DART SERVICE INSTRUCTION

TO AMEND INSTALLATION INSTRUCTIONS II135-21 REV. J
AND INSTRUCTIONS FOR CONTINUED AIRWORTHINESS ICA135-21 REV. F
OR LATER APPROVED REVISIONS

A	NEW ISSUE (Ref ECR 391)	SAD	22.04.28
REV.	DESCRIPTION	BY	DATE
DESIGN	SAD	DART AEROSPACE LTD HAWKESBURY, ONTARIO, CANADA	
DRAWN	SAD		
CHECKED	MB	DRAWING NO.	REV. A
MFG. APPR.	N/A	DSI 9884	SHEET 1 OF 2
APPROVED	CP	TITLE	SCALE
DE APPR.	DS	REPLACEMENT FASTENERS	NTS
DATE	22.04.28	COPYRIGHT © 2022 BY DART AEROSPACE LTD. THIS DOCUMENT IS PRIVATE AND CONFIDENTIAL AND IS SUPPLIED ON THE EXPRESS CONDITION THAT IT IS NOT TO BE USED FOR ANY PURPOSE OR COPIED OR COMMUNICATED TO ANY OTHER PERSON WITHOUT WRITTEN PERMISSION FROM DART AEROSPACE LTD.

Figure 1 - Support Angle Installations

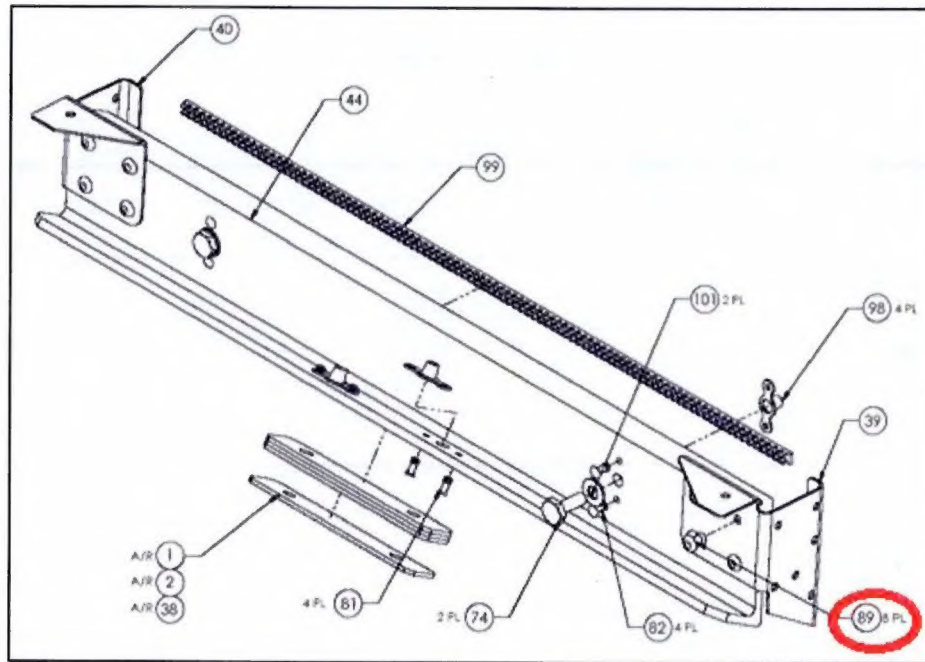
Step 7 from Section 4.0 of II135-21 cannot be accomplished due interference from existing equipment installed on the aircraft. Also, there is not enough clearance to insert the required tool to drive some of the rivets in place.

With reference to Figure 1 of this DSI, it is acceptable to install the Support Angle P/N 647.1915 (F/N 44) and Gusset P/Ns 647.1814/1815 (F/N 39 and 40) using shear Hi-Loks and Hi-Lok Collars in lieu of 601.1915 Rivets (F/N 89). Figure 1 and the tables on page 2 this DSI clarify changes to parts shown in Figure 22 and Table 10 of II135-21. The changes are circled in red.

IS:

F/N	Qty (7332)	P/N	Description
89	8	HL18PB5-3* HL70-5*	Hi-Lok Hi-Lok Collar

*: Acceptable alternate P/Ns: HL18PB6-3 (Hi-Lok) and HL70-6 (Hi-Lok Collar)
